# /// RAPID NEWS

NO: RN/DACE/BDS/ DACE-##-##

**Nordic Kit option availability**

## **1. Description**

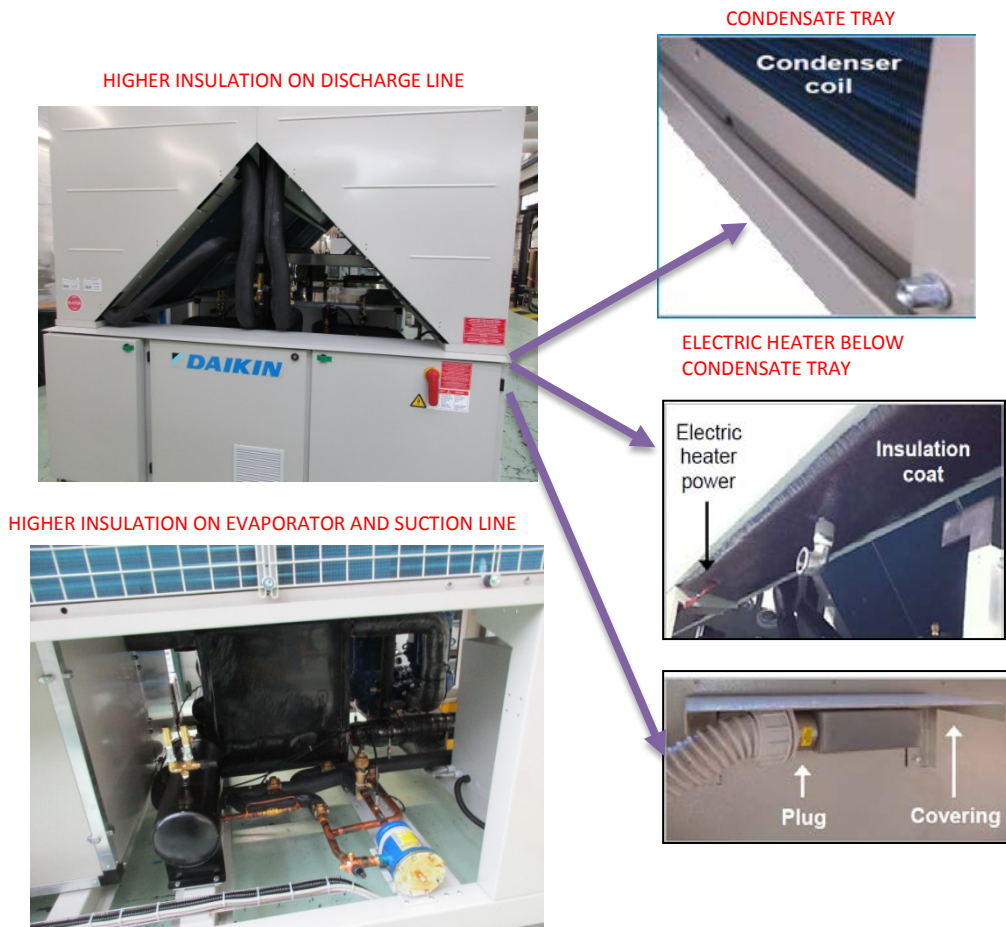
The option is provided for heat pumps and is necessary for very cold climate conditions. It is composed by:

- Higher level of insulation on the evaporator, suction and discharge lines (EWYQ-F, EWYD-BZ, EWYQ-G)
- A condensate tray heater protected by insulating material in order to avoid freezing of the water (only for EWYQ-F and EWYD-BZ)
- Additional covers for plugs positioned at the back side of the electrical panel

The Nordic kit option (number 114 in the Price list) is offering enhanced drain pans and water discharge line, electric heaters on the pans protected by insulating material and additional covers for plugs at the back side of the electrical panel.

It brings benefits below 0°C ambient temperature. It is recommended in case of high humidity or snow environment. **It is required for operation below -5 ° C ambient temperature.**

In addition, under the trays there are some joints to connect hoses on-site which are helping to drain the water from the coils to a desired location for the end-user, thus avoiding water/ice on the walking area around the units.
